- **SUSPENSION—REAR—BODY ROLL, SWAY OR LOW RIDE HEIGHT—DUAL REAR WHEEL CUTAWAY MODELS BUILT FROM JOB 1 1992 THROUGH 5/1/93 AND SINGLE REAR WHEEL CUTAWAY MODELS BUILT FROM JOB 1 1992 THROUGH 3/23/94 AND STRIPPED CHASSIS MODELS**
- **RIDE QUALITY—BODY ROLL, SWAY OR LOW RIDE HEIGHT—DUAL REAR WHEEL CUTAWAY MODELS BUILT FROM JOB 1 1992 THROUGH 5/1/93 AND SINGLE REAR WHEEL CUTAWAY MODELS BUILT FROM JOB 1 1992 THROUGH 3/23/94 AND STRIPPED CHASSIS MODELS**

**Article No.
95-9-6**

FORD: 1992-1994 E-30, E-33, E-350, E-37, E-39

Figure 1 - Article 95-9-6

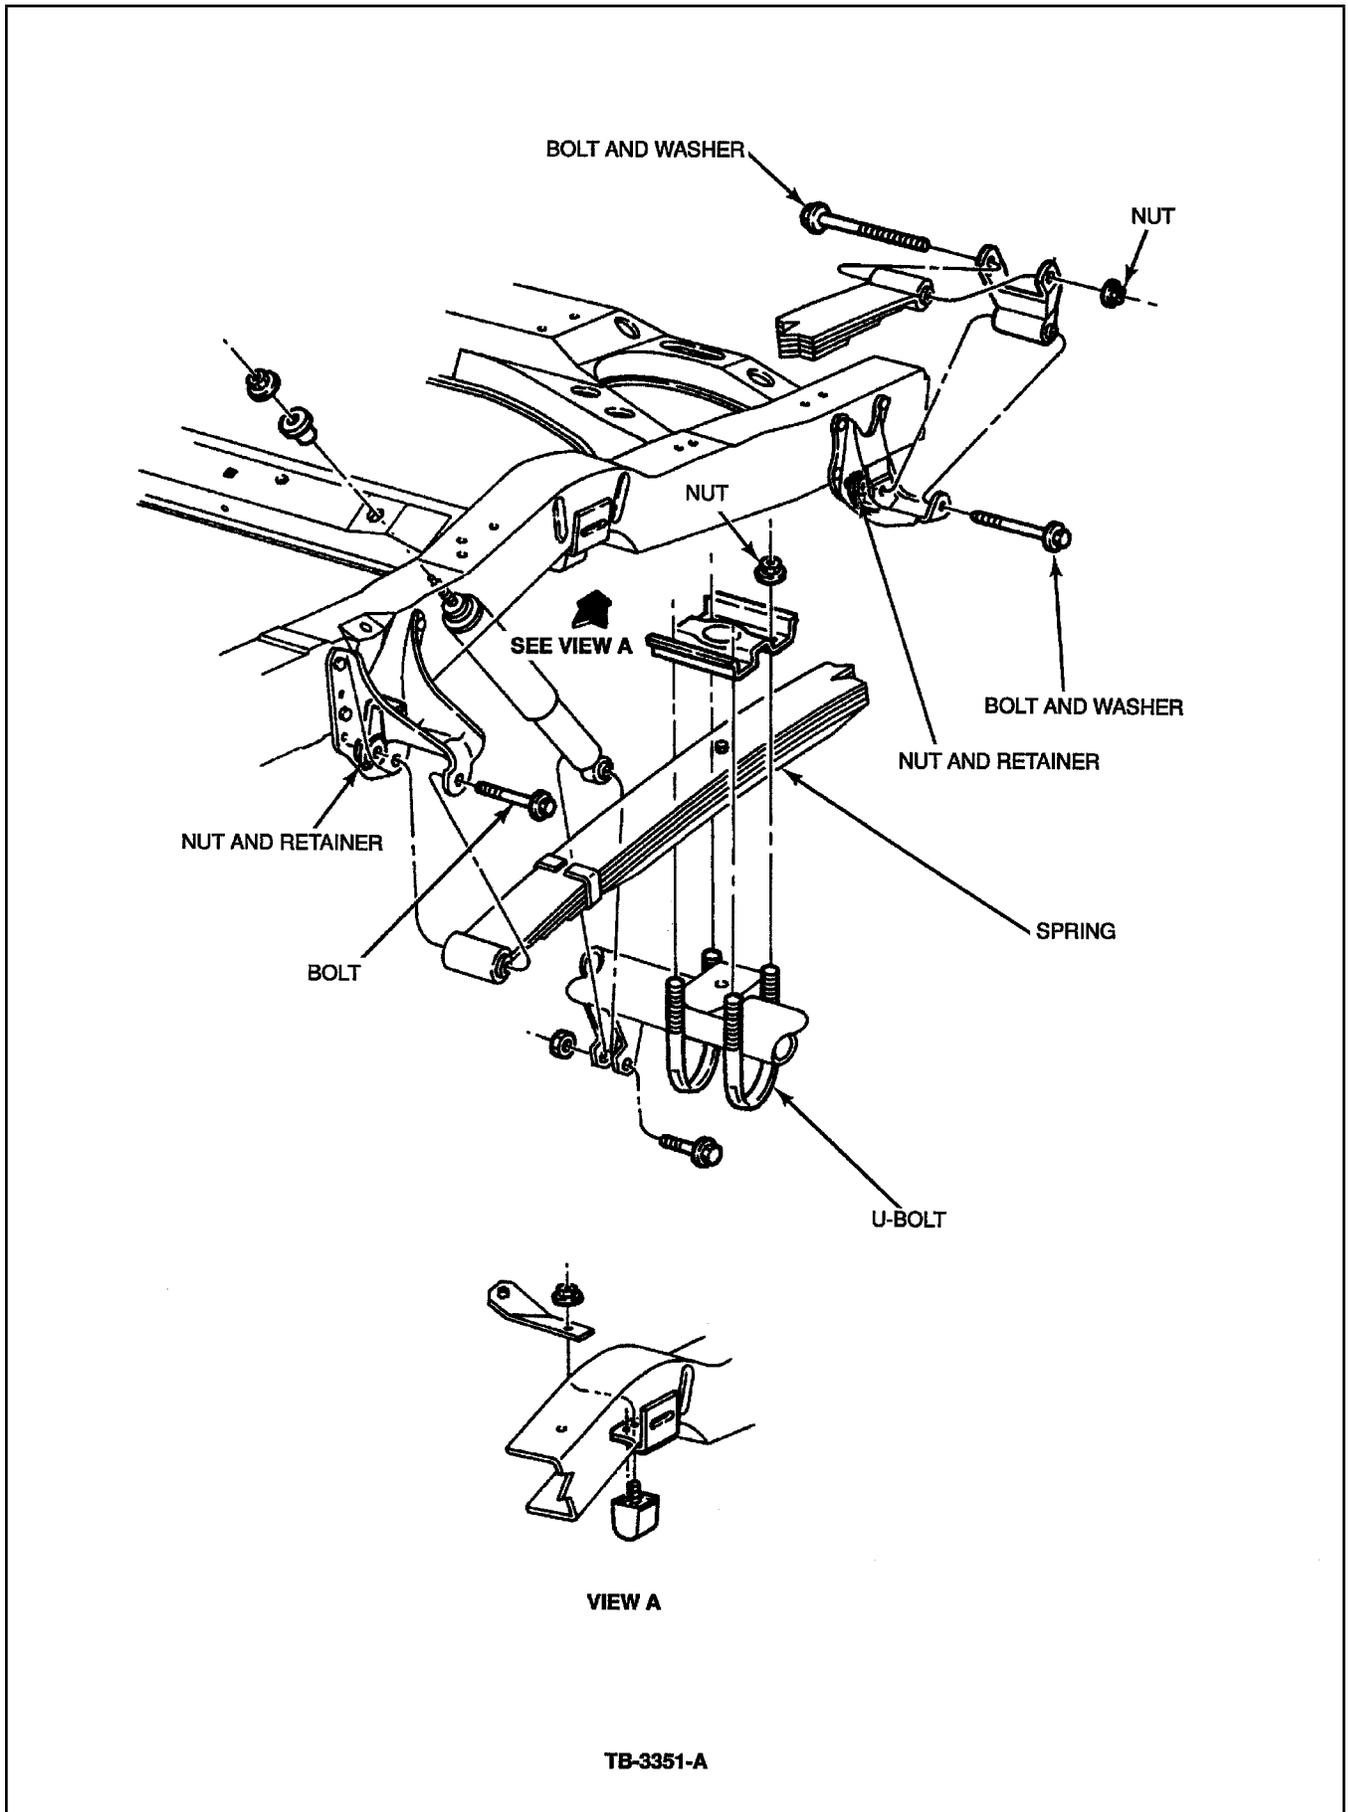
Install the new 9-leaf spring which will increase interleaf spring friction and raise the rear of the vehicle 1.25" (32mm). Refer to the following procedure for service details.

DISCARD OLD SPRING U-BOLTS AND INSTALL THE NEW LONGER U-BOLTS (REQUIRED FOR THE 9-LEAF SPRING), REINSTALLING ORIGINAL NUTS.

2. Tighten U-bolts to 150-210 lb-ft (203-285 N•m).

REFER TO FIGURE 1 AND PARTS LIST FOR ADDITIONAL PARTS THAT MAY BE REQUIRED DUE TO DAMAGE WHEN REMOVED.
